**BROOKDALE INDUSTRIAL PARK SUBDIVISION, UNIT  
ONE, RESUBDIVISION OF AND ADDITION TO LOTS  
13 & 15**

Engineering Comments: FINAL PLAT COMMENTS (should be addressed prior to submitting the FINAL PLAT for review and/or signature by the City Engineer):

# DETAIL SITE PLAN

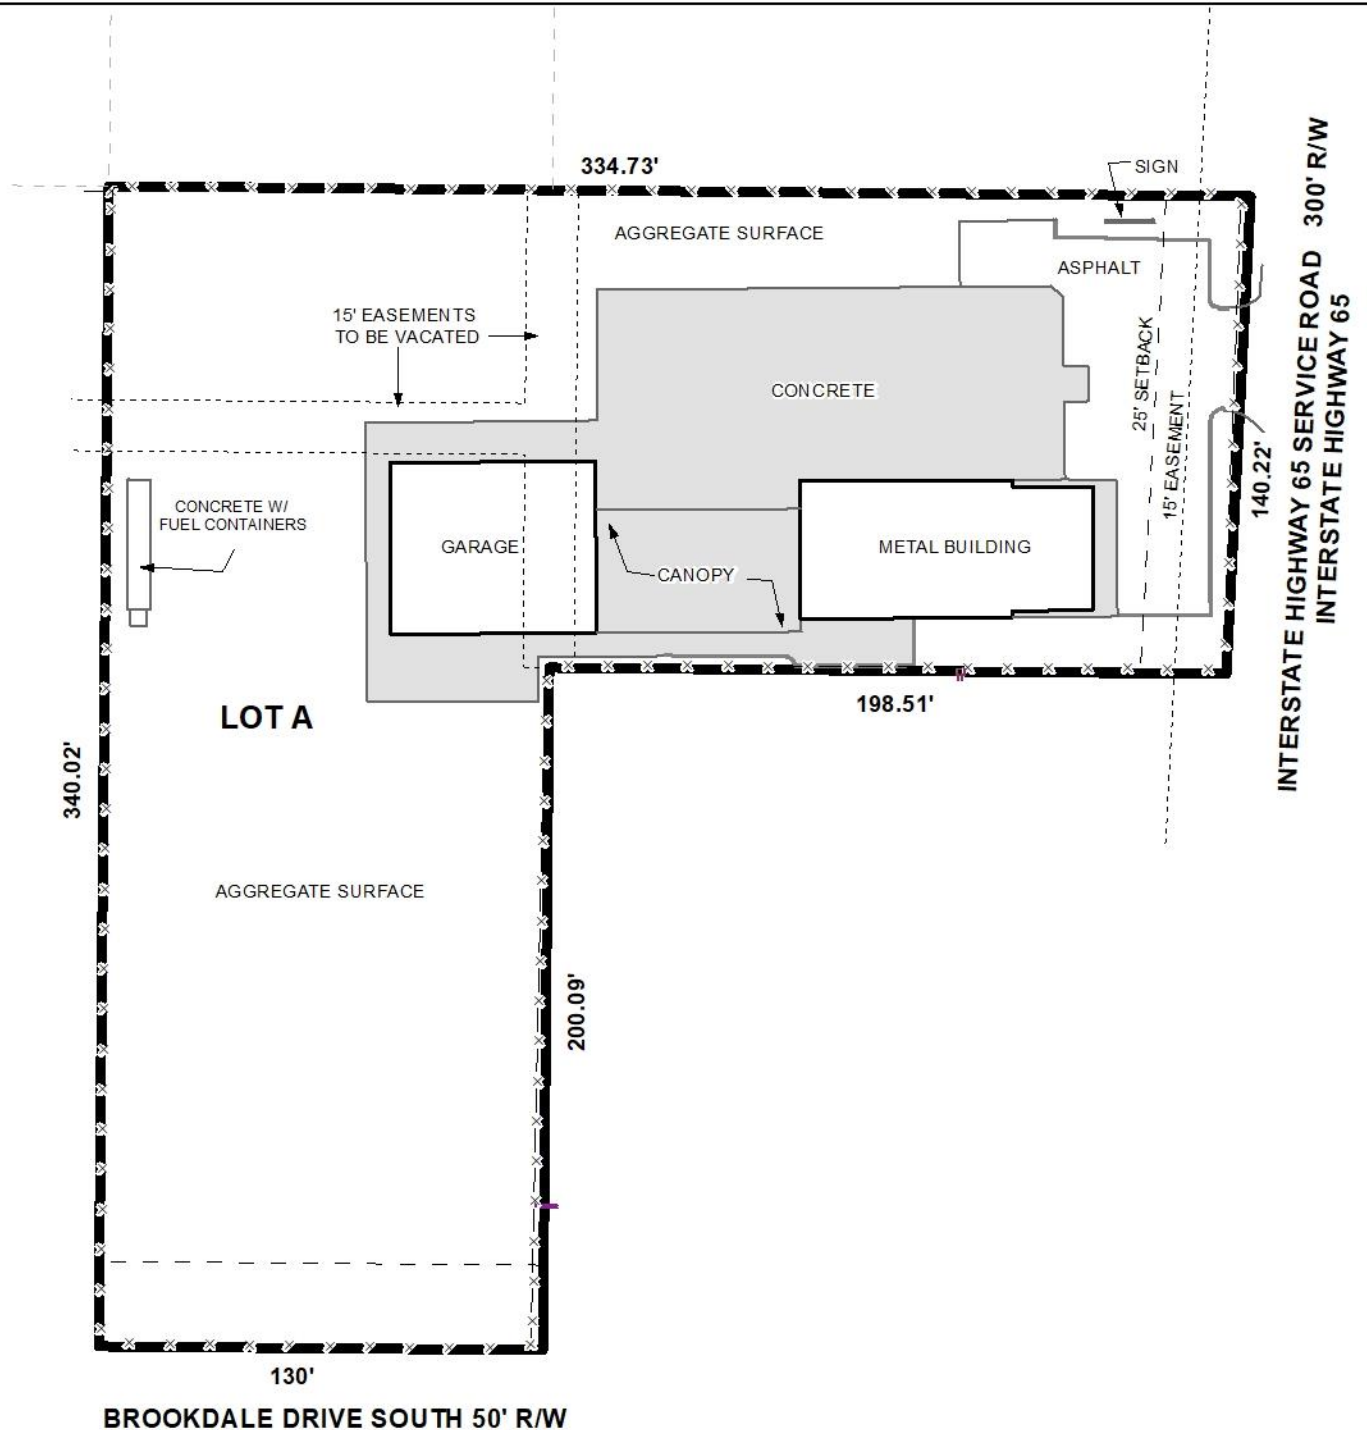
As proposed, the lot will have frontage along Brookdale Drive South and the West Interstate 65 Service Road North. Brookdale Drive South is a minor road with curb and gutters, and has a compliant right-of-way width of 50', making no dedication necessary. West Interstate 65 Service Road North is a major street with an existing compliant right-of-way of 300', making no dedication necessary.

The proposed lot exceeds the 7,200 square foot minimum required by Section V.D.2. of the Subdivision Regulations, with the lot size provided in square feet and acres. If approved, this information should be retained on the Final Plat.

The 25' minimum required front setback is depicted along both frontages, and should be retained, if approved. It should be noted that there are several easements illustrated on the preliminary plat, with some of them marked as "to be vacated". Therefore, the applicant should complete the easement vacation process through the City Clerk's office prior to the signing of the Final Plat, if approved. Furthermore, if approved, a note should be placed on the Final Plat stating that no structures are allowed in any easement without the permission of the easement holder.

As a means of access management, a note containing the Traffic Engineering comments should be placed on the Final Plat.

- 1) Completion of the easement vacation process through the City Clerk's office prior to the signing of the Final Plat;
- 2) Retention of the lot sizes in both square feet and acres, or the furnishing of a table on the Final Plat providing the same information;
- 3) Retention of the 25' minimum building setback along both frontages;
- 4) Placement of a note on the Final Plat stating that no structure may be constructed or placed within any easement without permission of the easement holder, if applicable;
